Report Type: DA Access Report

Site Address: 971 Richmond Road, Marsden Park NSW.

ACCESS REPORT

This Access Compliance Report is to accompany a Development Application for the development proposed at 971 Richmond Road, Marsden Park, NSW.

Building C, E, F Pre-adaptation layout

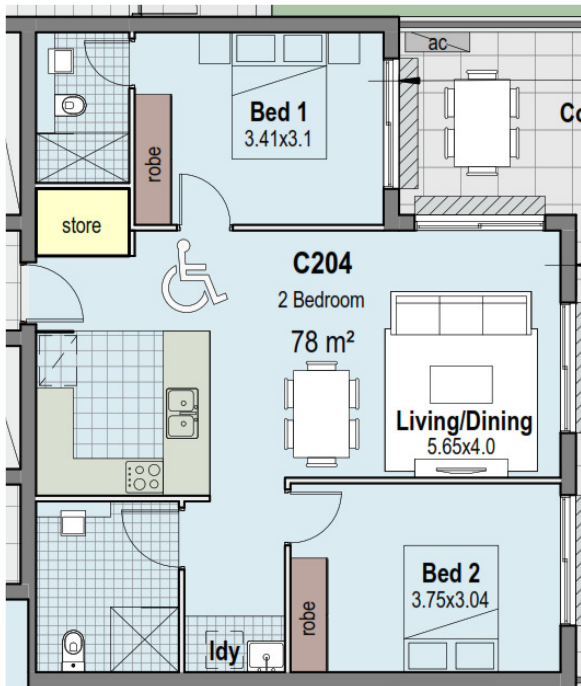
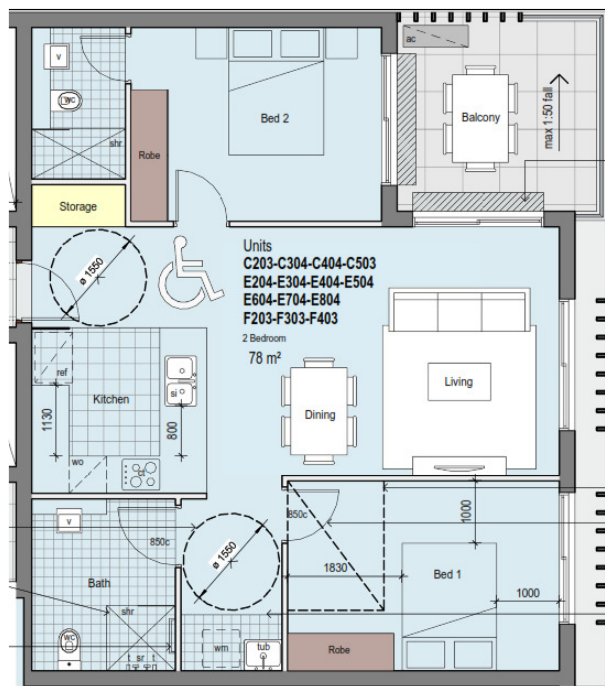
Note: Unit C203 is noted on the post adapt plan and this should be C204.

Note: At post adaptation a minimum clear space of 1550mm is required between the kitchen benchtops
